**COLLECTOR WINDFARM
LANDSCAPE CHARACTER AND
VISUAL IMPACT ASSESSMENT
PEER REVIEW
S13-0011 10.05.2013**

COLLECTOR WIND FARM
LANDSCAPE CHARACTER AND VISUAL IMPACT ASSESSMENT
PEER REVIEW

NSW Department of Planning & Infrastructure
23-33 Bridge Street
Sydney
NSW
2000
Australia

Figure 2 Preferred project proposal for the Collector Wind Farm (Image sourced from Preferred Project & Submissions Report, 2013, APP)

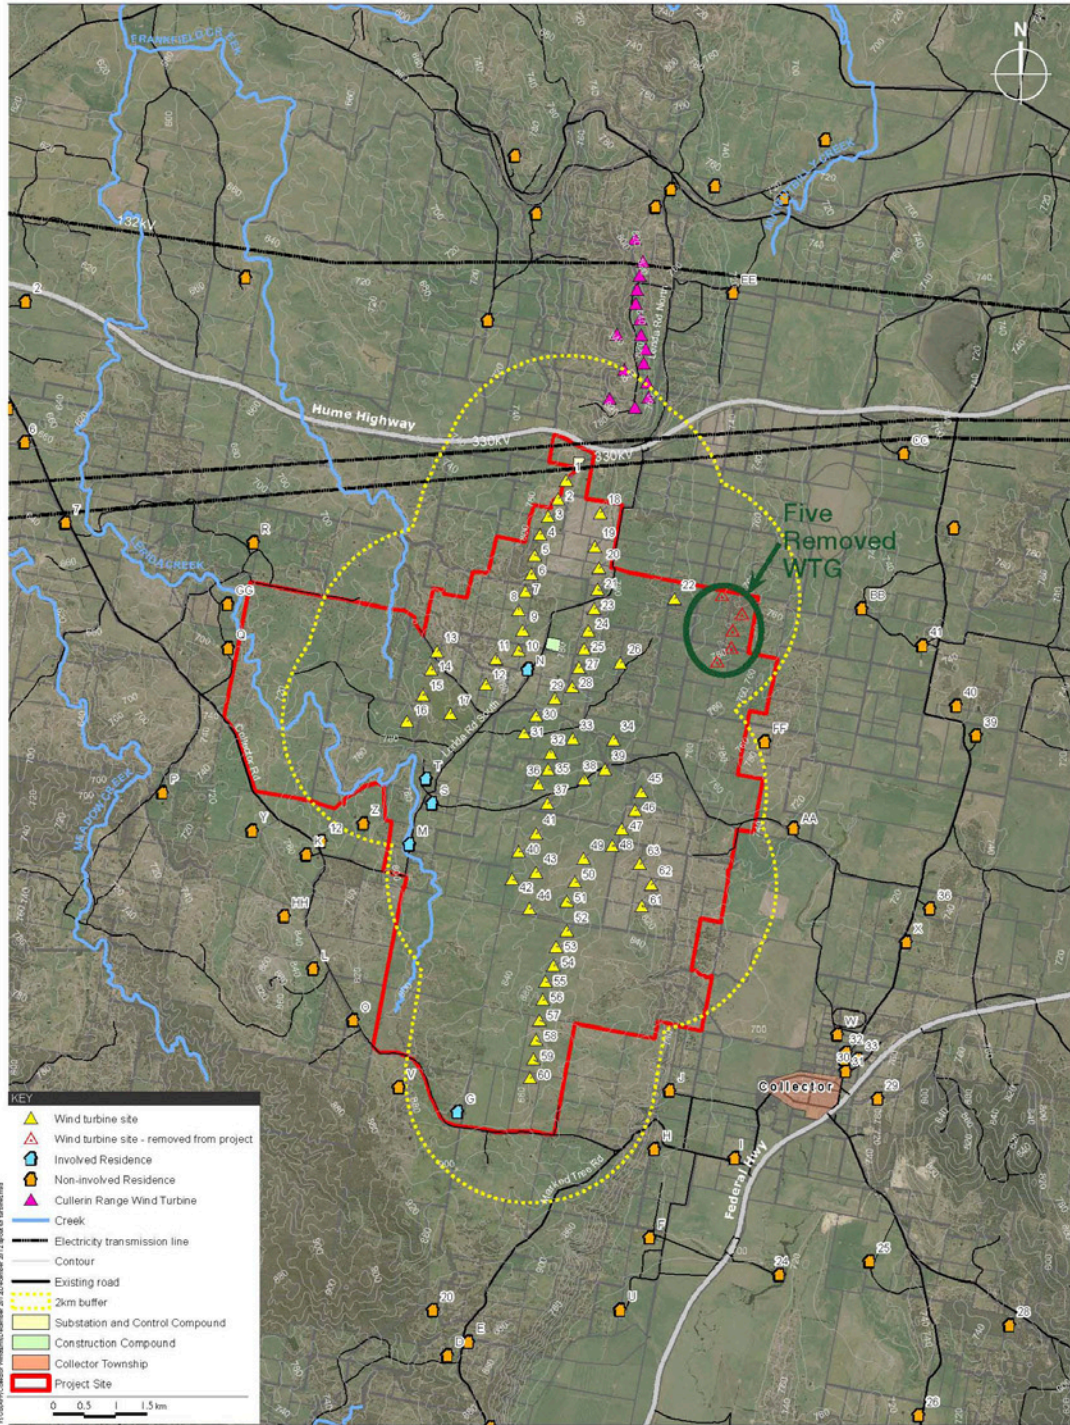
The Collector Wind Farm (The Preferred Project) proposal seeks approval for the erection of 63 wind turbines measuring 150 metres from ground to tip of blade and associated electrical works. This review assesses the Environmental Assessment (APP, June 2012) submitted with the proposal, specifically the LVIA which was undertaken by Green Bean Design (GBD) and photomontages by Truescape Visual Communication. The original project proposal sought approval for 68 turbine wind farm. Five turbines have subsequently been proposed for removal (see Figure 2)
